SUBDIVISION REVIEW SHEET
(VARIANCE ONLY)

CASE NO.: C8-2017-0124

SUBDIVISION NAME: Lightfield Preliminary Plan

MEMORANDUM

PRELIMINARY PLAN

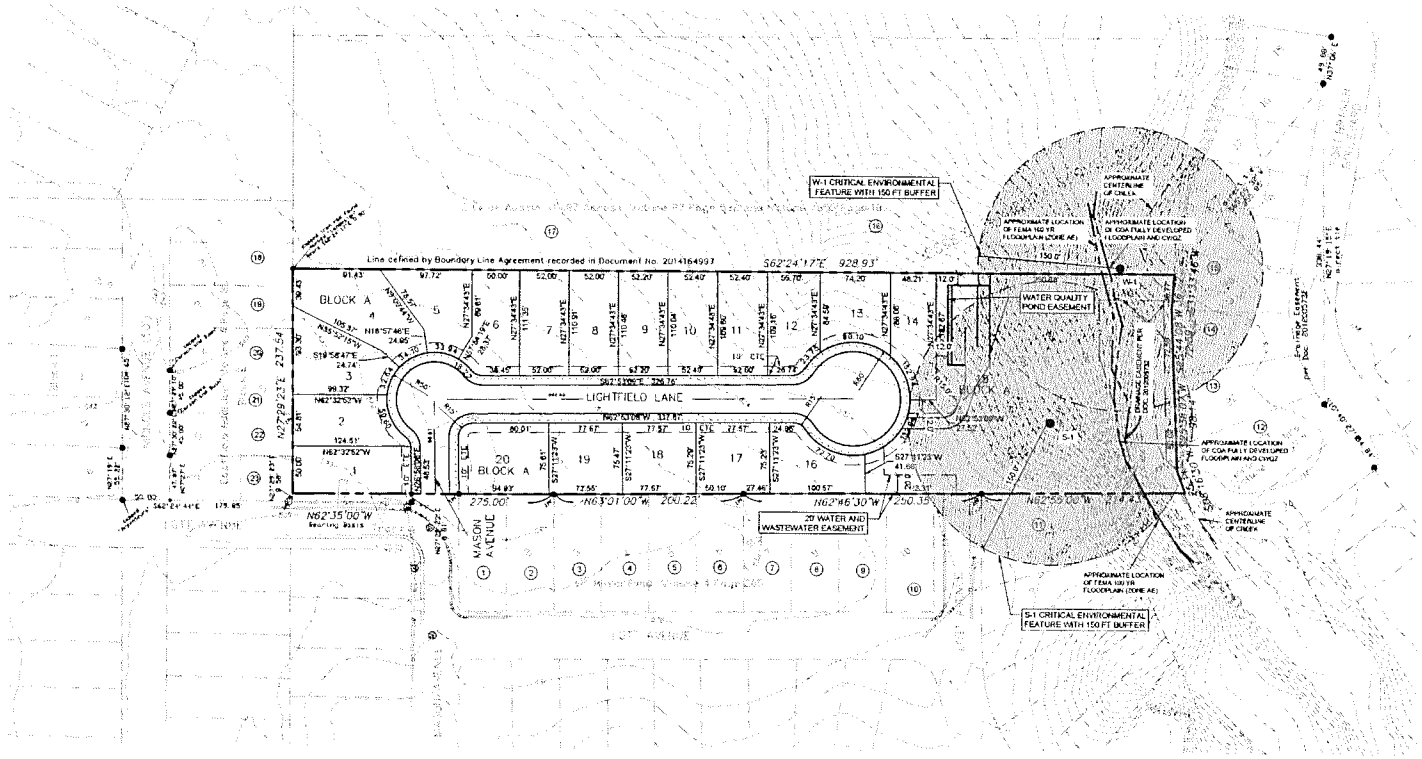
The applicant for the above referenced subdivision is requesting a variance to Title 25 of the Land Development Code (LDC) Section 25-4-151, which requires streets of a new subdivision to be in line with existing streets on adjoining property. The variance is for the connection to Lott Avenue.

- Lott Avenue is an existing collector street which provides access to the single-family residential units to the south.
- Traffic circulation would not be compromised if Lott Avenue was not extended because there are other ingress and egress points throughout this subdivision and adjacent subdivisions to right-of-way.
- After discussions with staff, Lott Avenue extension is not supported due to environmental and topographic constraints adjacent to the existing right-of-way. In accordance with the Comprehensive Master Plan, Imagine Austin, staff has agreed to support the proposed single-family residential development within the Urban Core with recommended conditions.

- The site shall dedicate a minimum 20-foot sidewalk, trail, and recreational easement from Lott Avenue to the proposed Lightfield Lane right-of-way cul-de-sac.

- A minimum 10-foot ADA accessible pedestrian and bicycle path shall be constructed, in accordance with City of Austin standards, within the 20-foot sidewalk, trail, and recreational easement at the time of the subdivision construction application.

- The proposed Mason Avenue 50-foot right-of-way shall be extended to the north property line to provide a connection to Springdale Park for pedestrian and bicycle access. The Mason Avenue ROW connection shall be constructed to City of Austin standards and provide collapsible bollards.
